108th session

**Proposals for amendments to annexes A and B of ADR:
construction and approval of vehicles**

Section 9.7.6 – Rear protection of vehicles

Transmitted by the Government of the United Kingdom

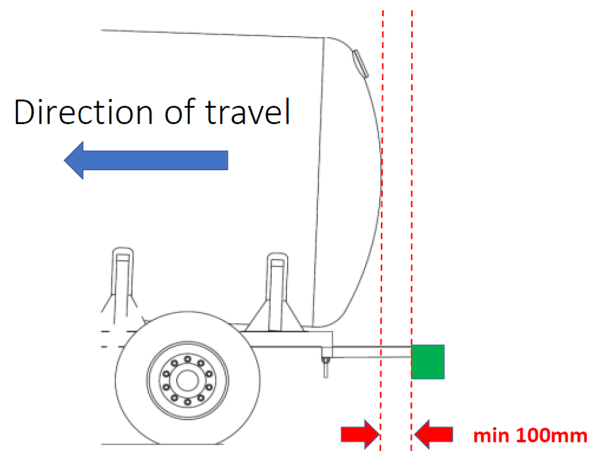
It is not clear however, how the clearance of 100 mm should be measured and in respect to the rear of the tank we believe the distance could be misinterpreted as follows:

5. To accurately define the 100mm clearance between the rear of the tank and the rear of the bumper, it is proposed that the text of proposal 1 within document ECE/TRANS/WP.15/2020/5 (changes to the second sentence of 9.7.6) should be amended to read (deleted text struck through and new text in bold and underlined):

“There shall be a clearance of at least 100mm between the rear ~~wall~~ of the tank, ~~or of its projecting fittings in contact with the substance being carried, and the face of the bumper facing the rear wall of the tank.~~ **and the rear bumper. This clearance shall be measured horizontally and parallel to the longitudinal axis of the vehicle between two transverse planes passing through the following points:**

(a) the extreme rearward part of the tank or of its projecting fittings or accessories in contact with the substance being carried and;

(b) the foremost part of the bumper in the direction of travel
